Addendum

New Glasgow Public Library & PARL Headquarters Revitalization

| 16 April 2024 | 23-053         | 04         |

A511

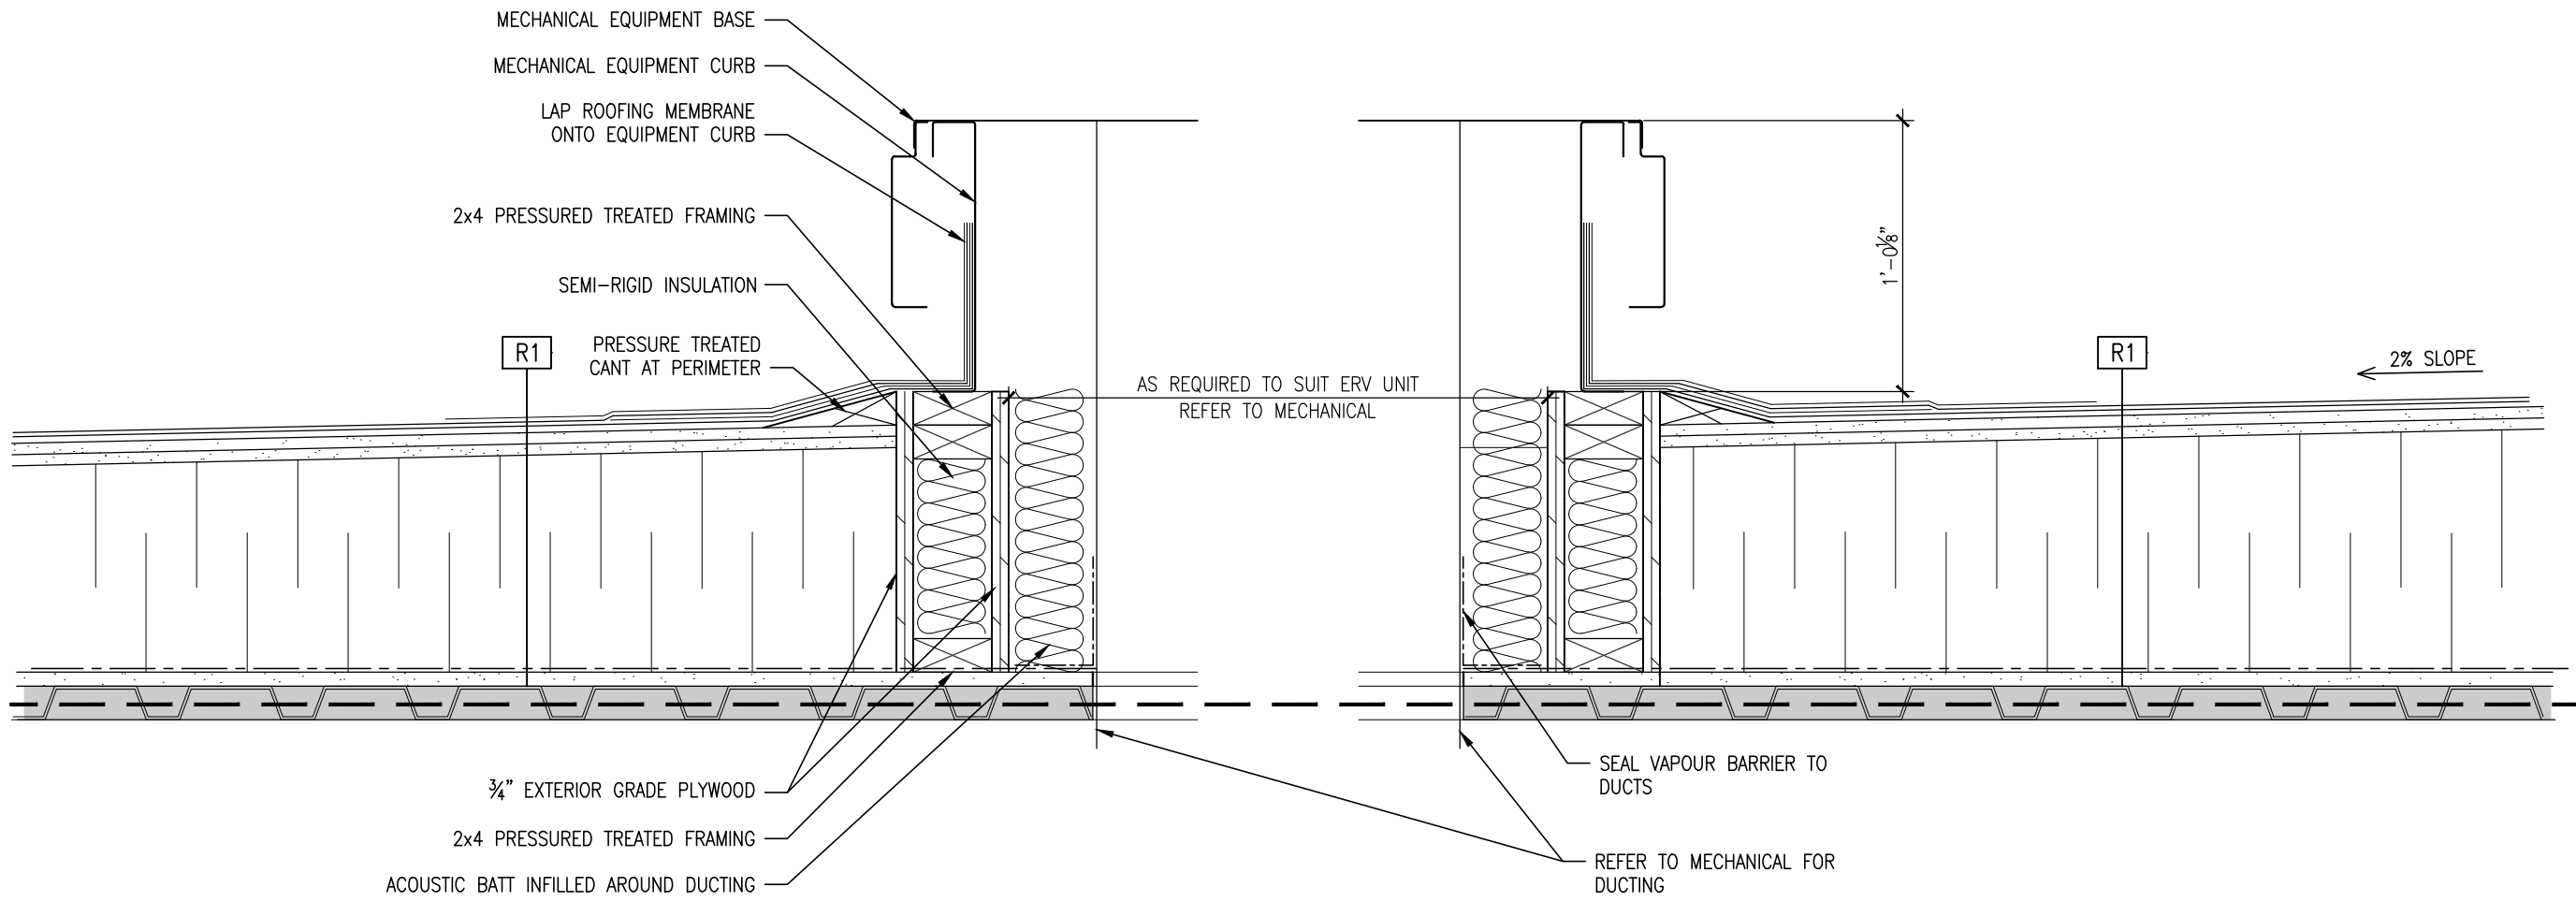
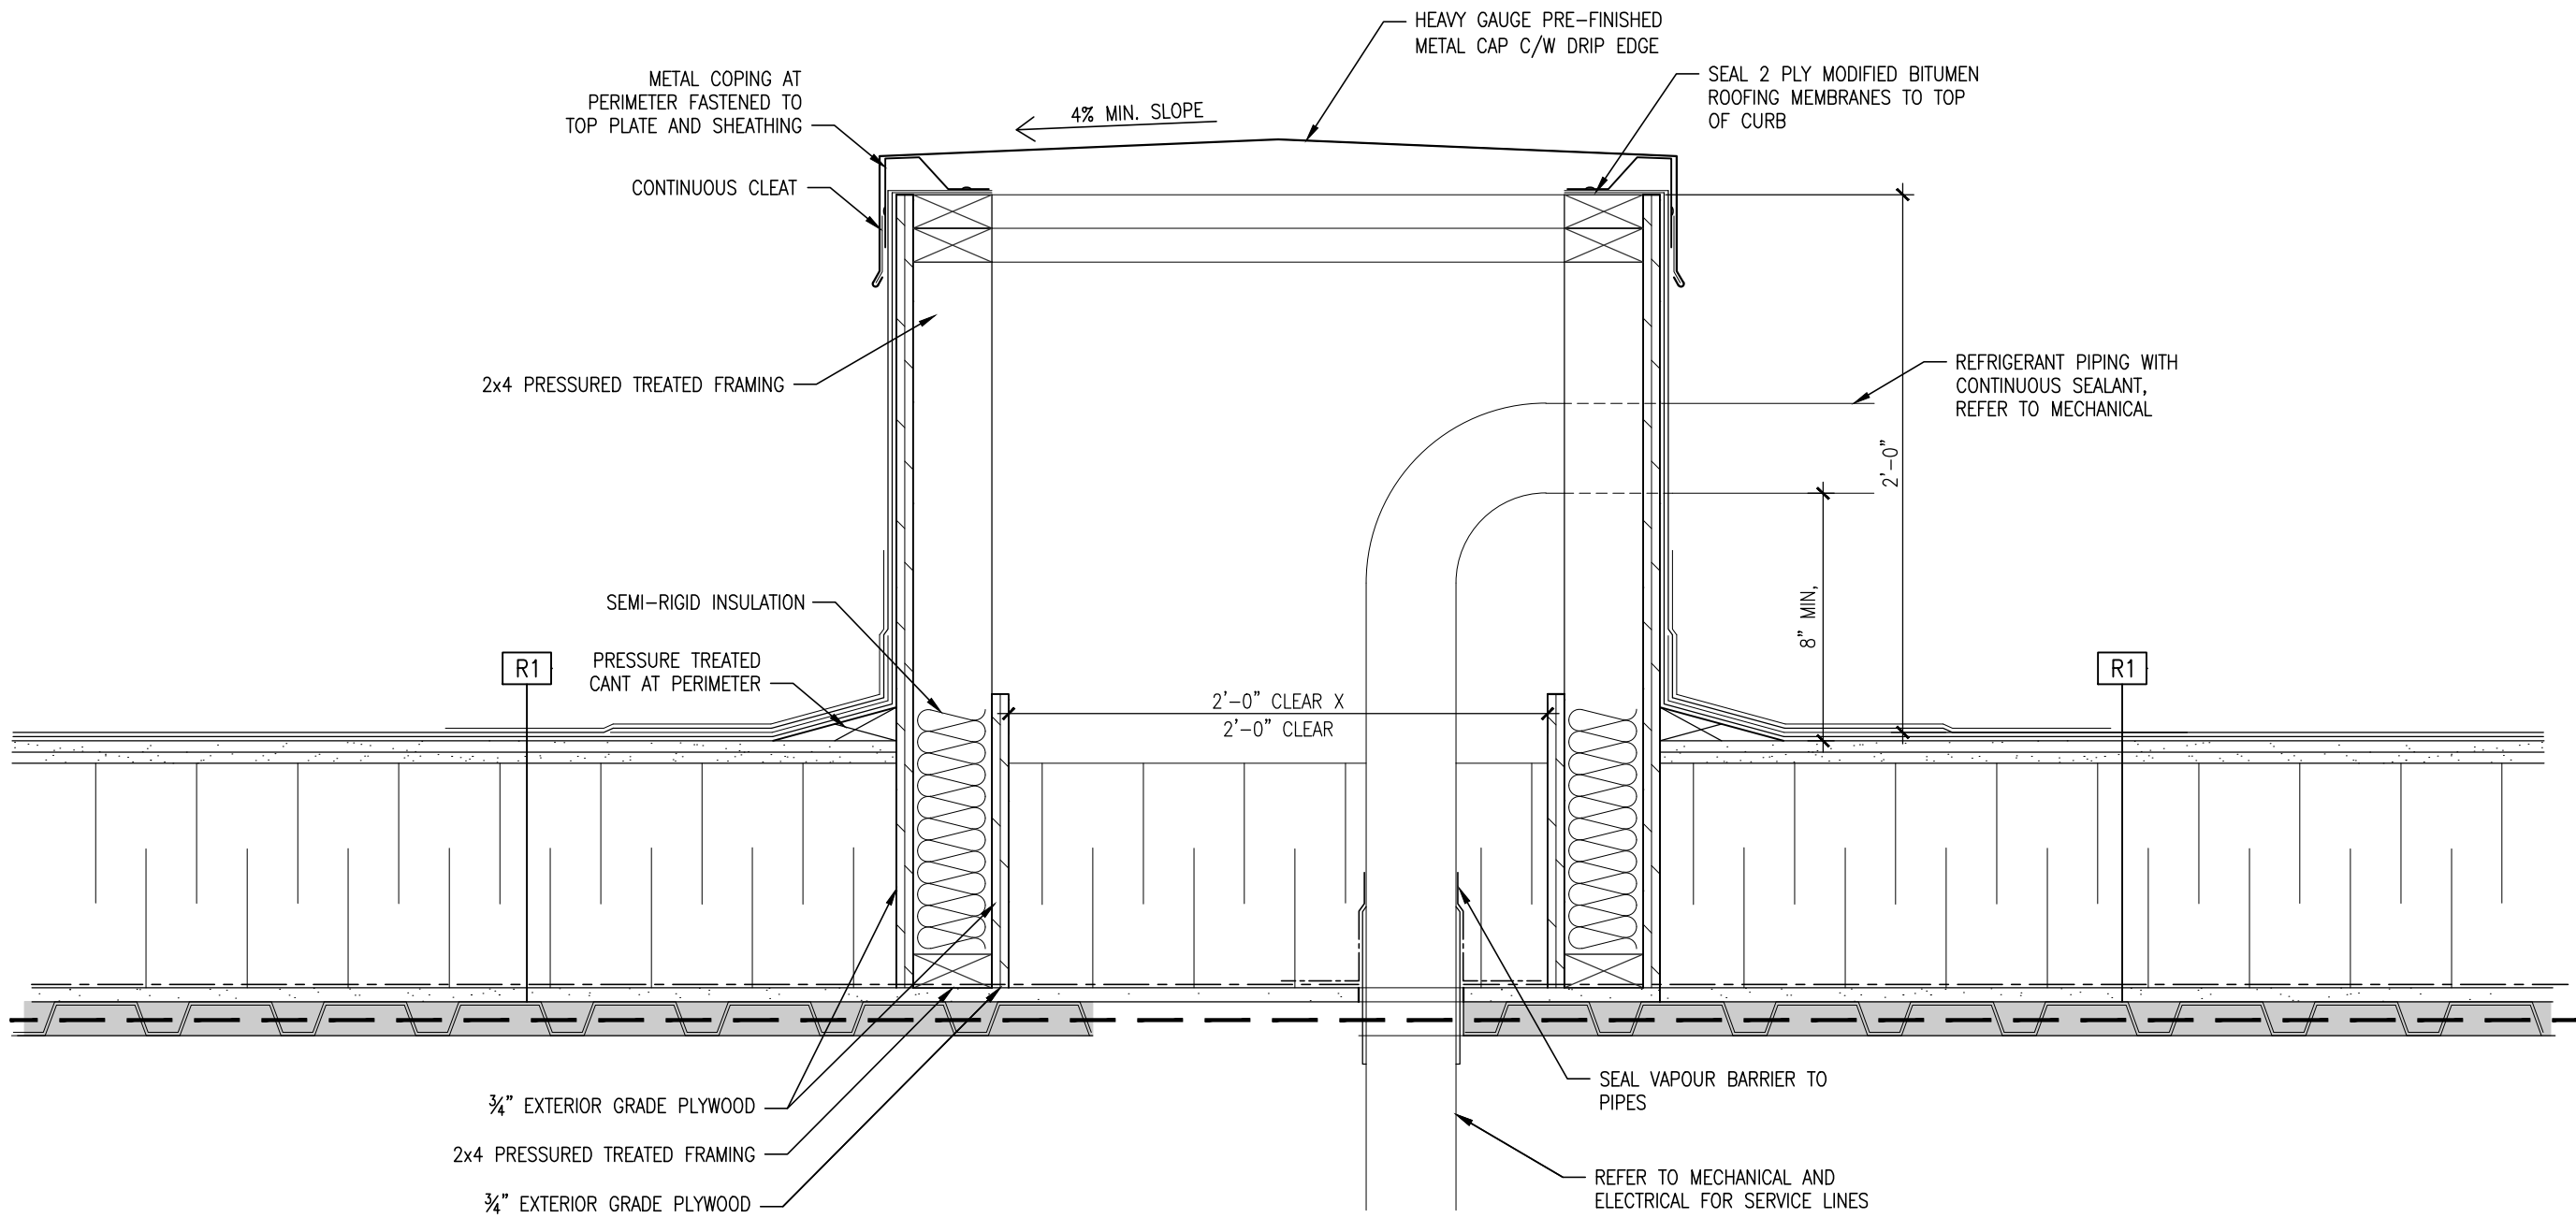
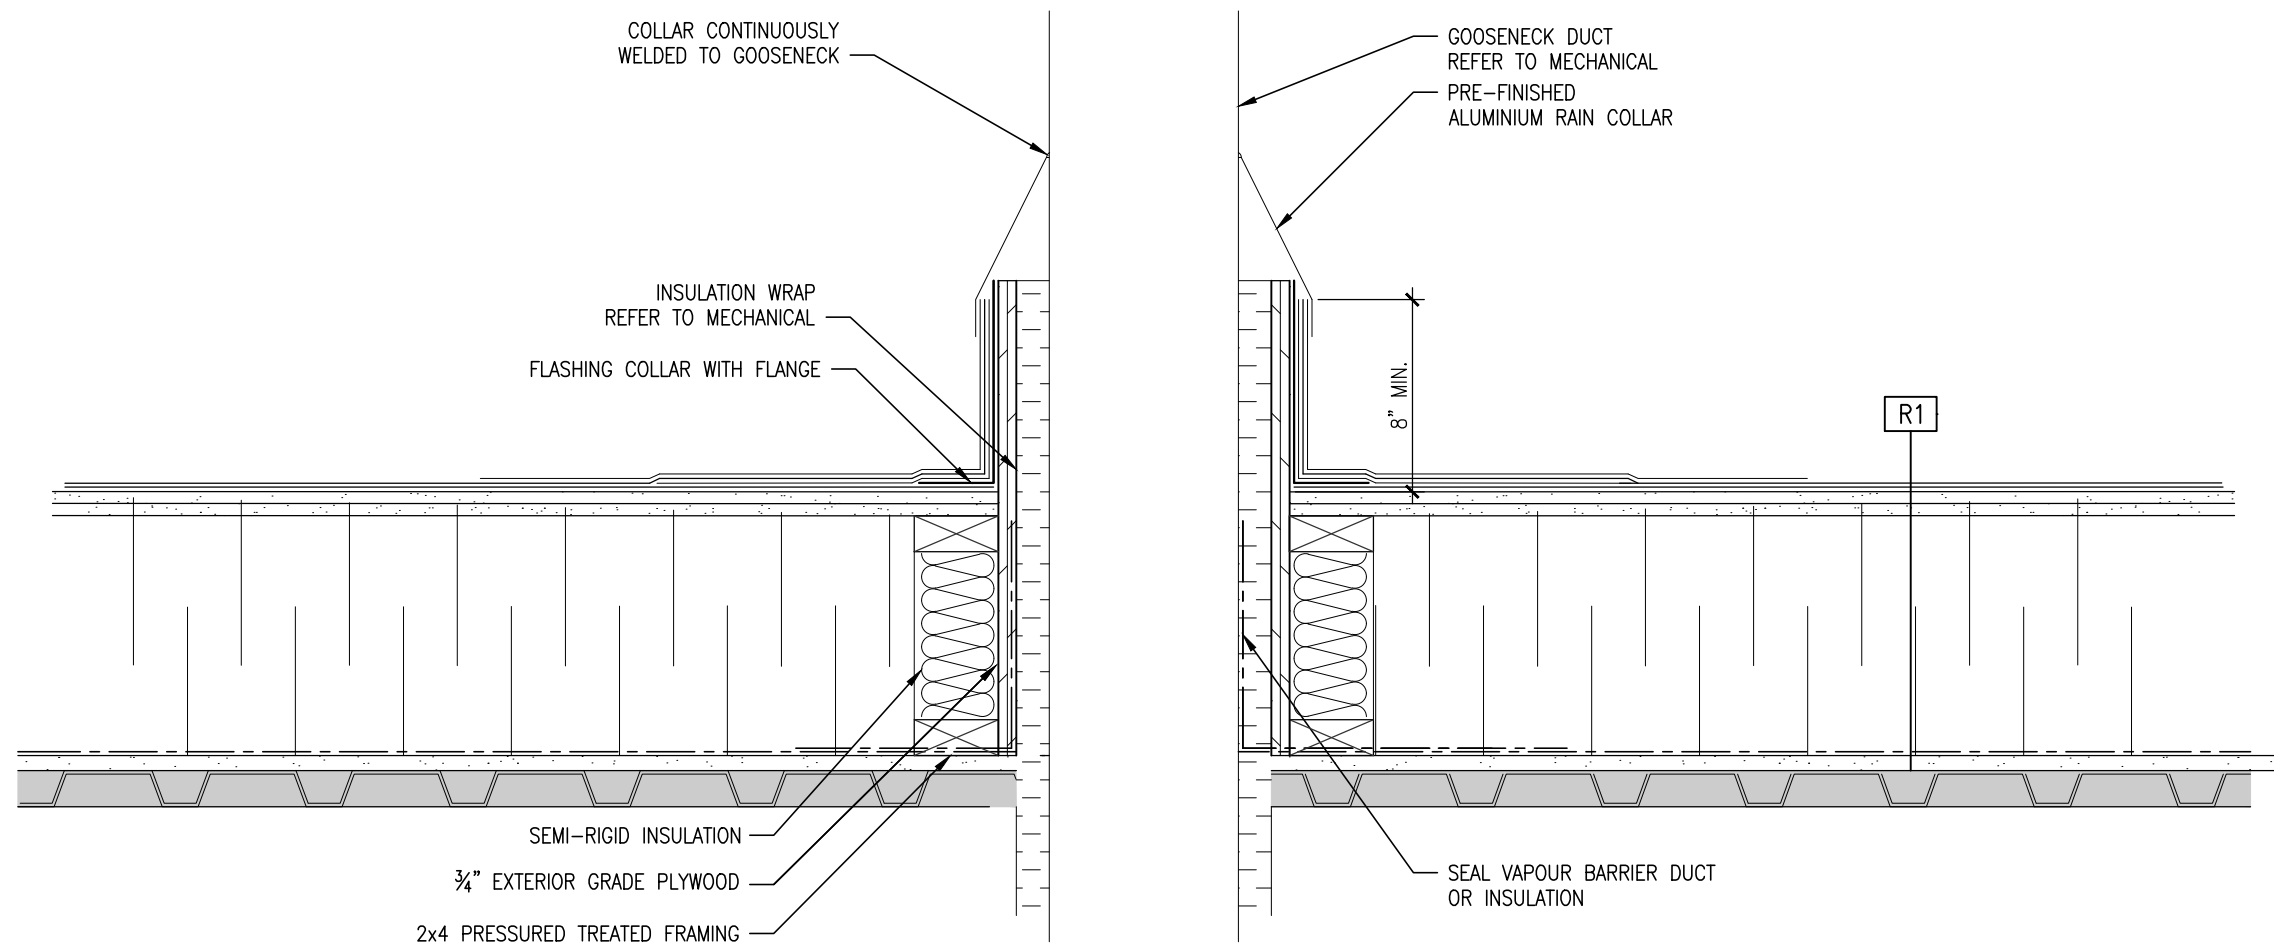
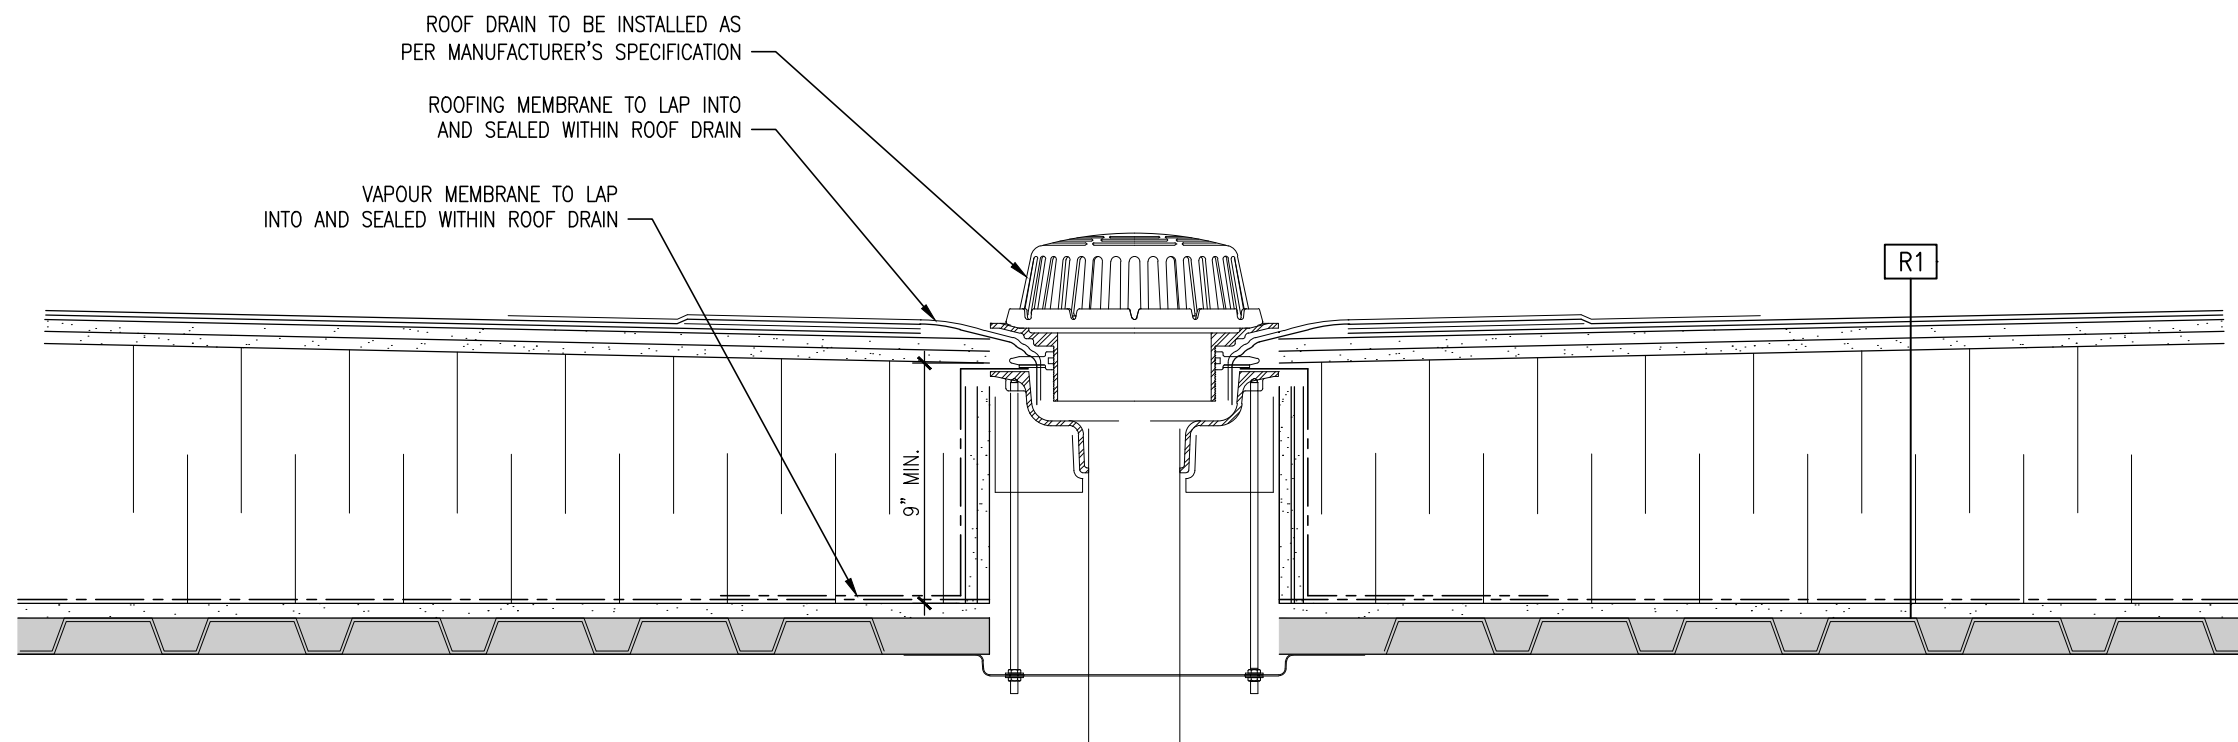
**2.7 Replace Drawing A511 Section Details:** New details of rooftop gooseneck, roofdrain, small doghouse (north roof above program room) and mechanical equipment curb.
